**ADDENDUM TWO (2)
IFB 20-PR-029
CONSTRUCTION OF A NEW SENIOR CENTER**

Addendum Number Two (2) forms part of the contract documents and modifies them in the manner set forth below.

RIO RANCHO
 SENIOR CENTER
 CITY OF RIO RANCHO
 NEW MEXICO

A301

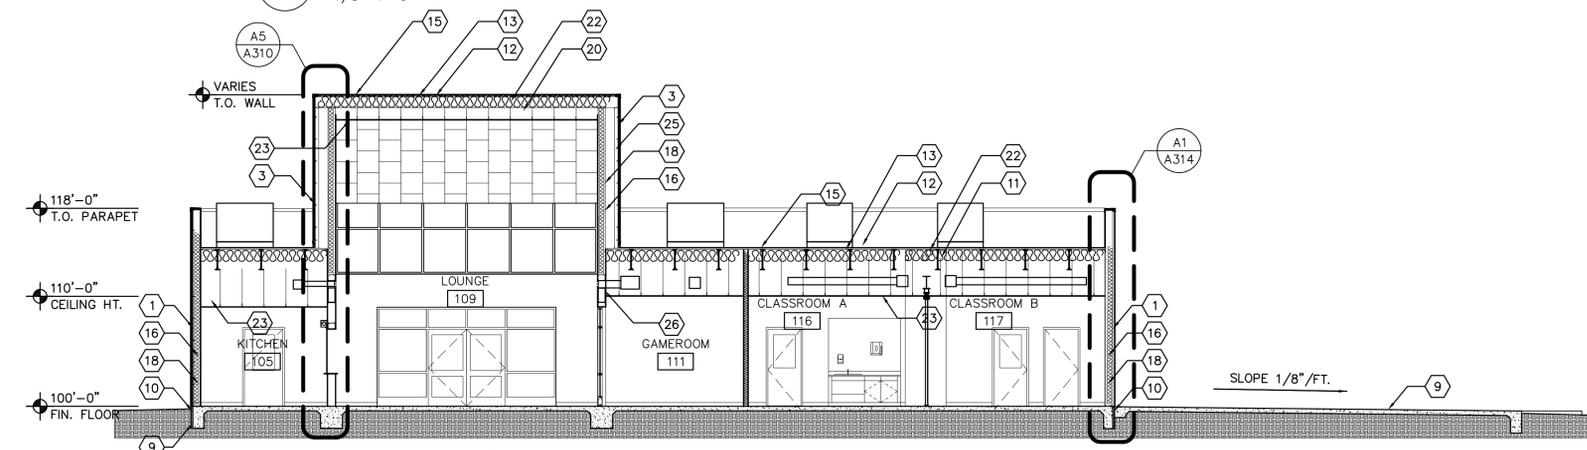
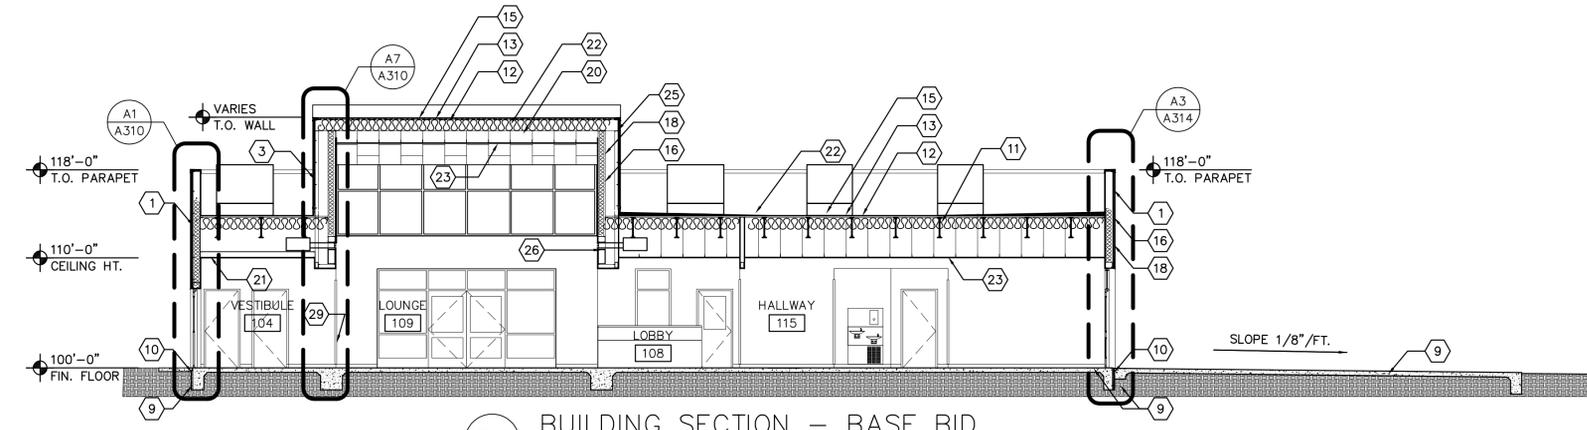
1. Left out of first printing

Question: The building sections for these walls are only shown on Page A303, which is for Add Alternate #1. Are these sections the same as the base bid, which is not shown anywhere, or are they different in some way?

Answer: Drawing Sheet A301 was left out of the original bid set and is now included as part of this addendum. Please refer to A301 to see that it shows the same building sections as Sheet A303, but without the multi-purpose room.

A501

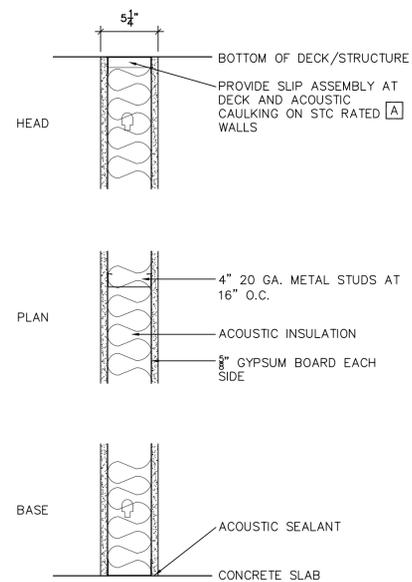
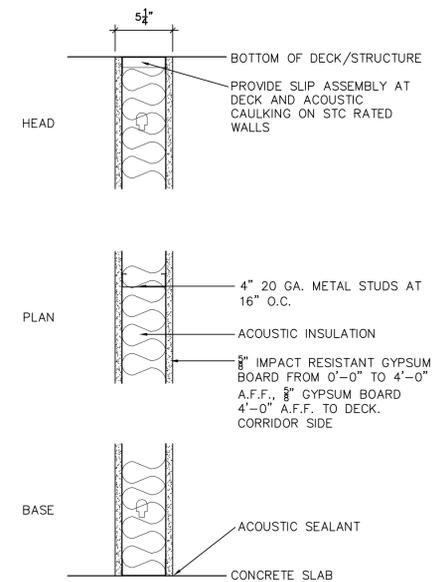
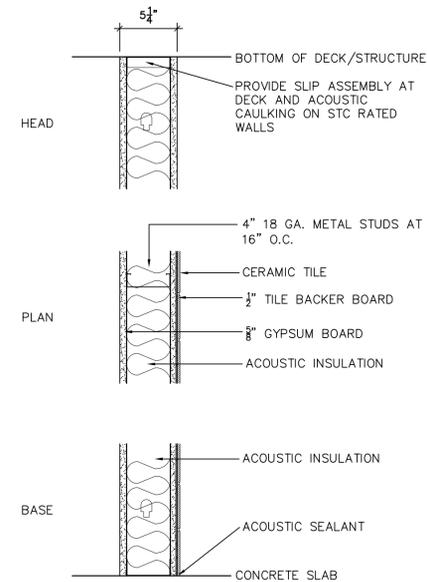
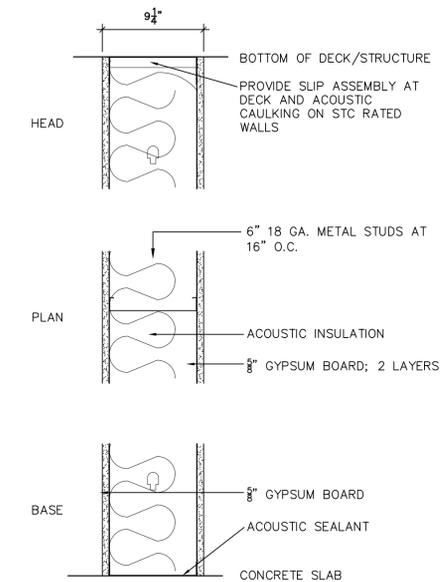
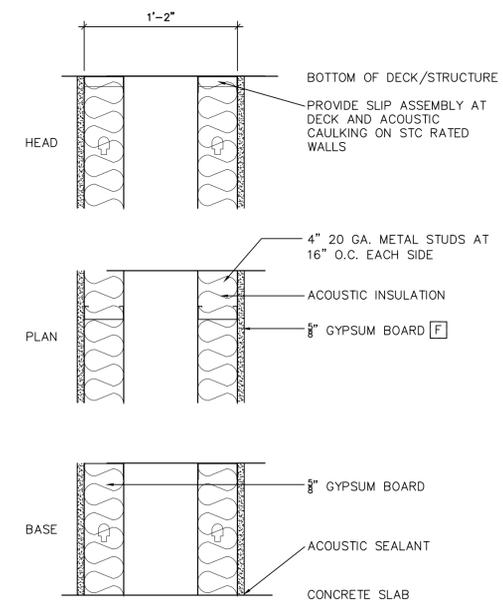
1. Reflects corrections to wall types

Question: Page A501 Wall Types, Wall Type D, is shown as 4" 18g. Structural drawings show them as 8" 18g. It also shows tile on one side. Is this applicable for all walls labeled Wall Type D?

Answer: Sheet A501 has been revised to clarify wall types. Replacement sheet is included as part of this addendum.

E001

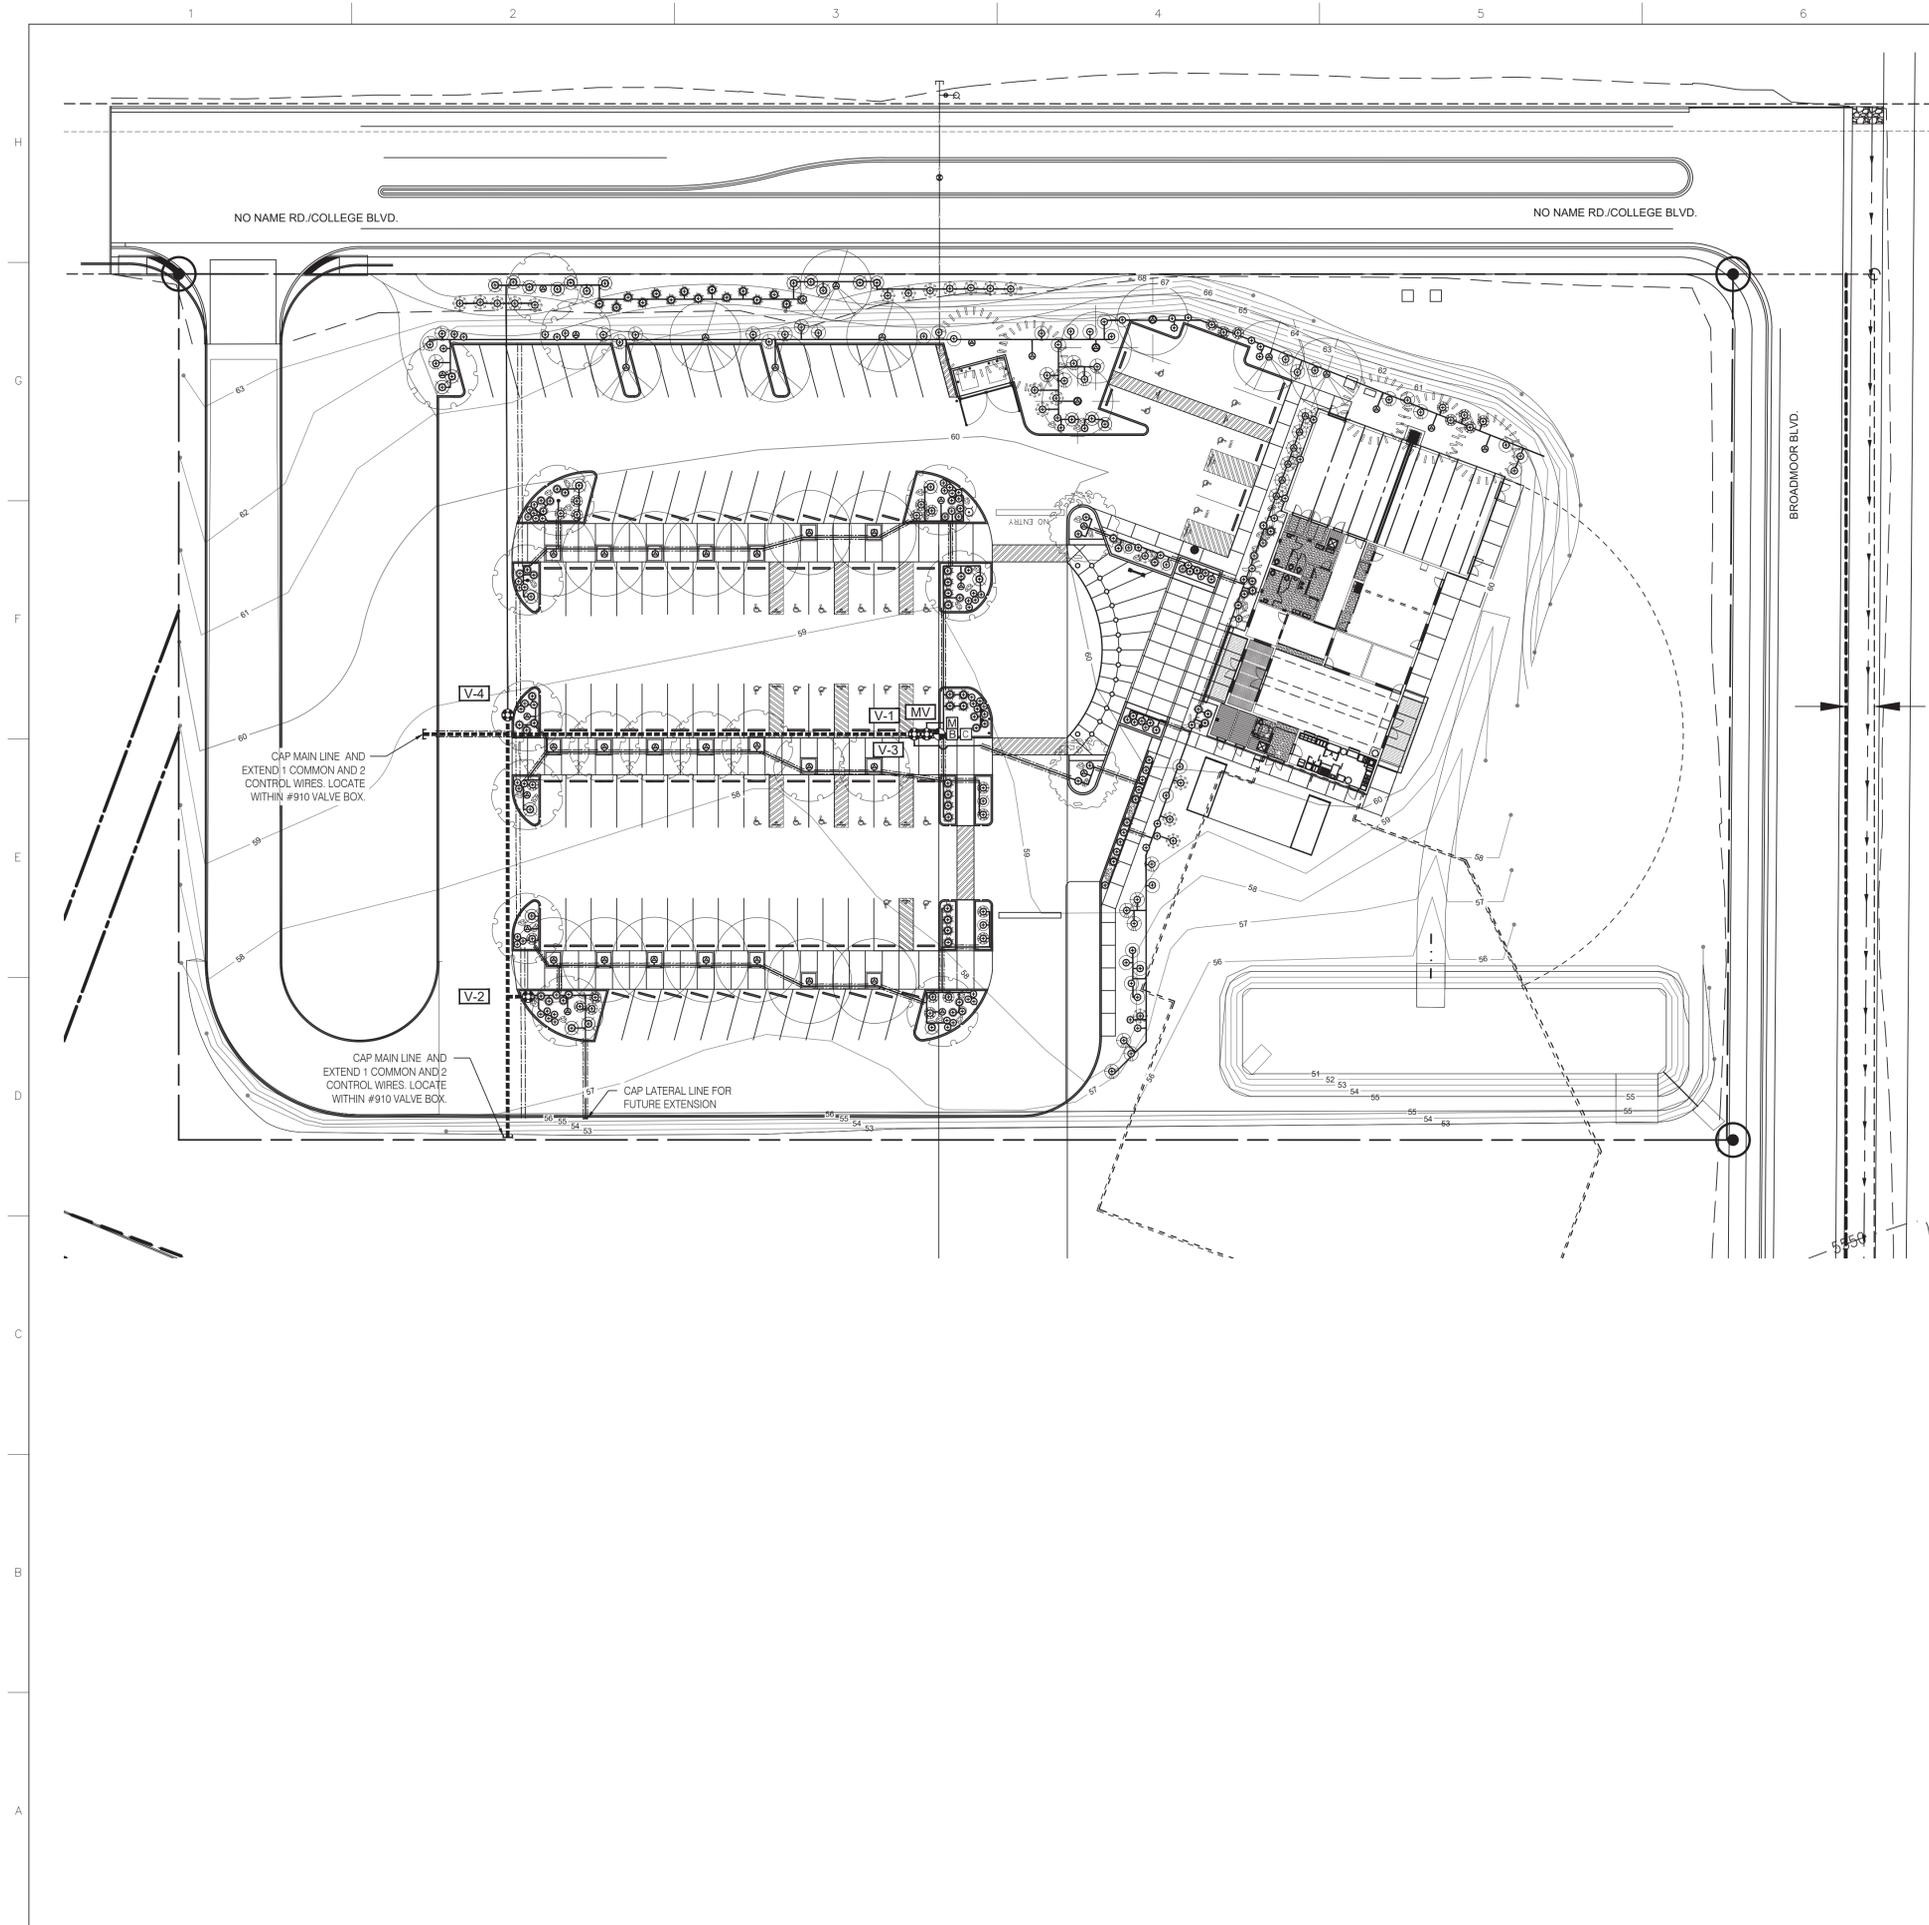
1. Reflects clarifications with regard to low voltage/special systems/fire alarm

Question: Is the Communication, Data, and Fire Alarm rough in only for contractors? The plans state such, however there is spec provided for each system.

Answer: Communication, Data, and Fire Alarm is GC responsibility for complete and operational system. The Owner will hire a separate contractor to rough-in and install Security and Intrusion.

- 1) Fire Alarm
 - a. Provide a complete and functions system.
 - b. See proposed layout on drawings
 - c. See specification 28 3111 Digital Addressable Fire Alarm System
- 2) Data system: The system includes but is not limited to the following:
 - a. See revised E001
 - b. Provide data rack with patch panel shown on EP101
 - c. Provide outlet locations as shown on plan
 - d. Provide CAT6 data cables between outlets and patch panel
 - e. See Division 27 specification

L-101

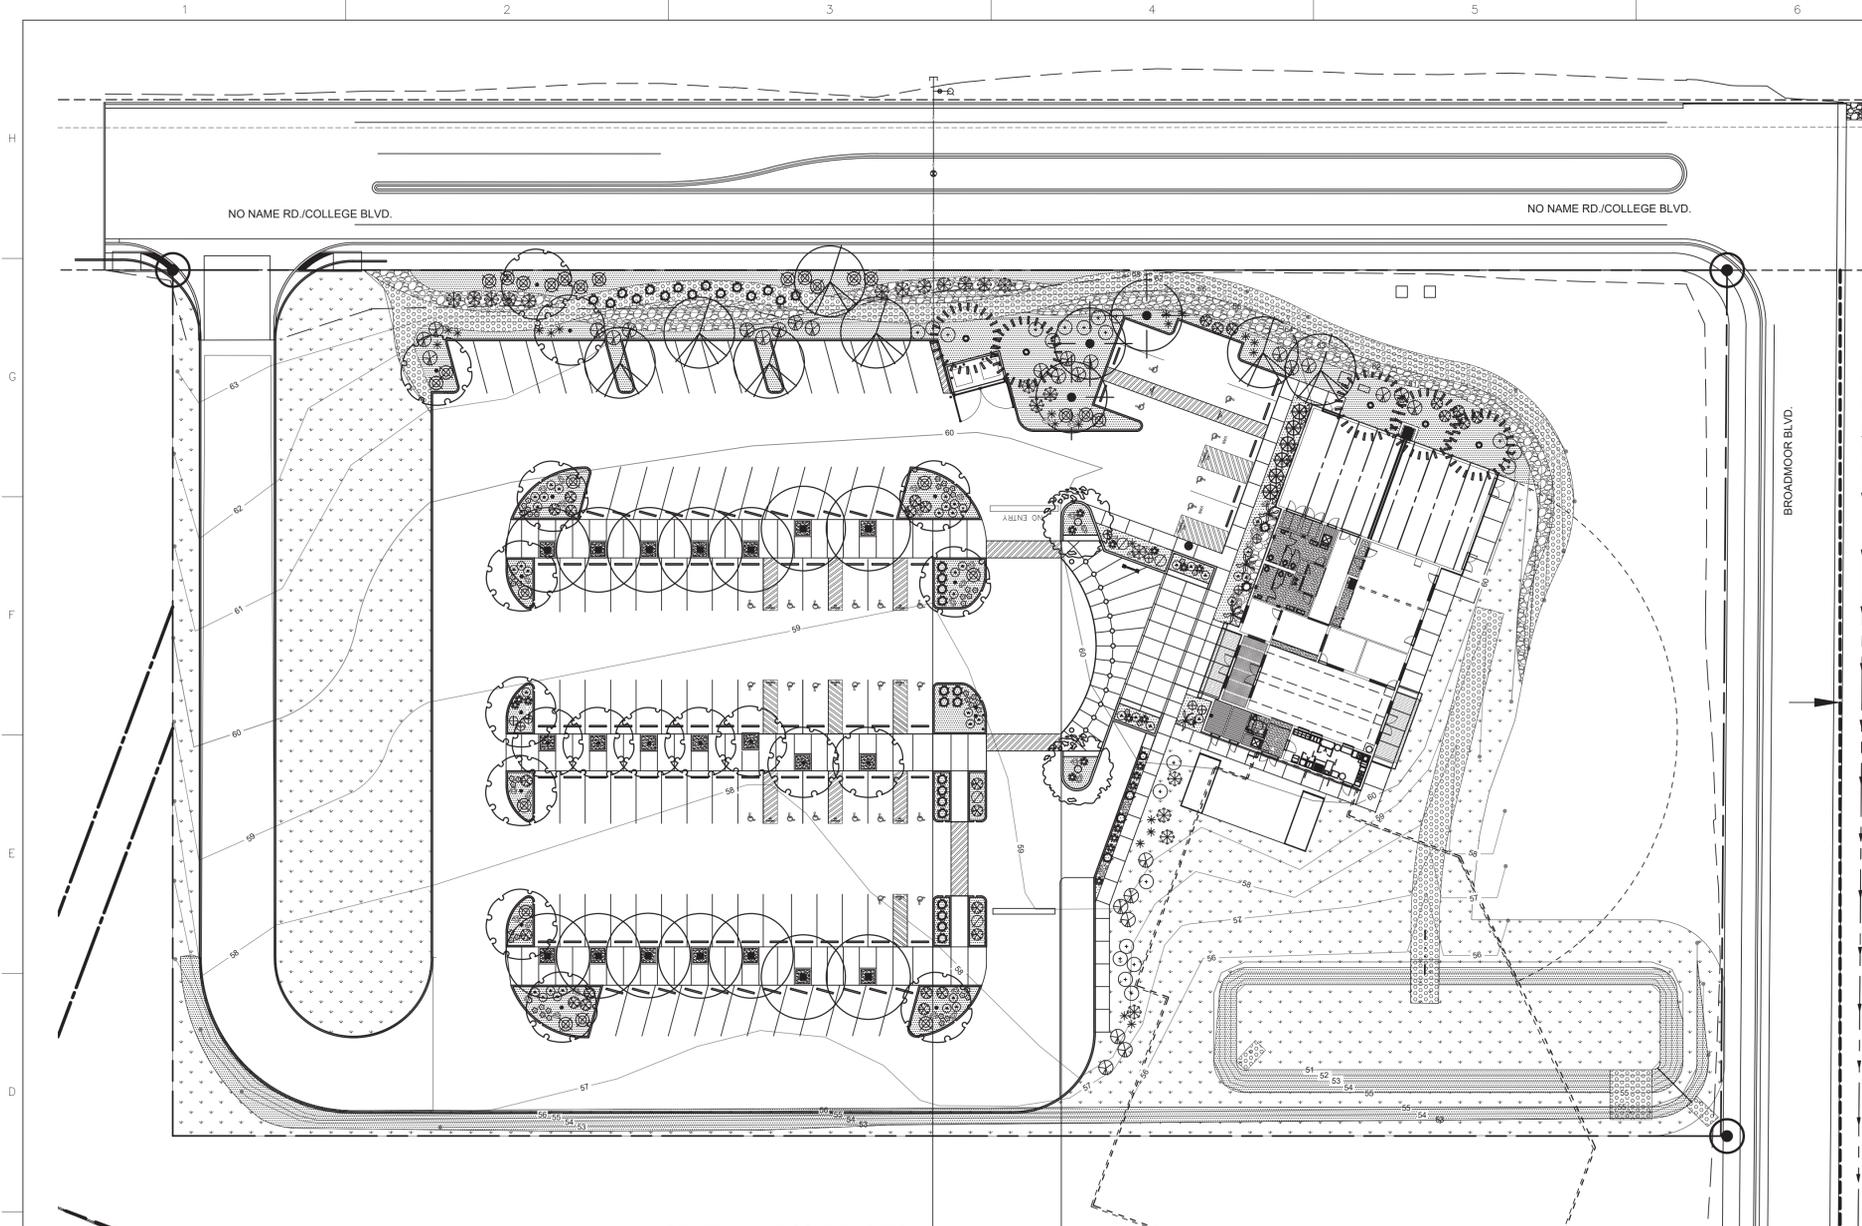
1. Reflect changes along the north side with regard to grading, planting and irrigation.
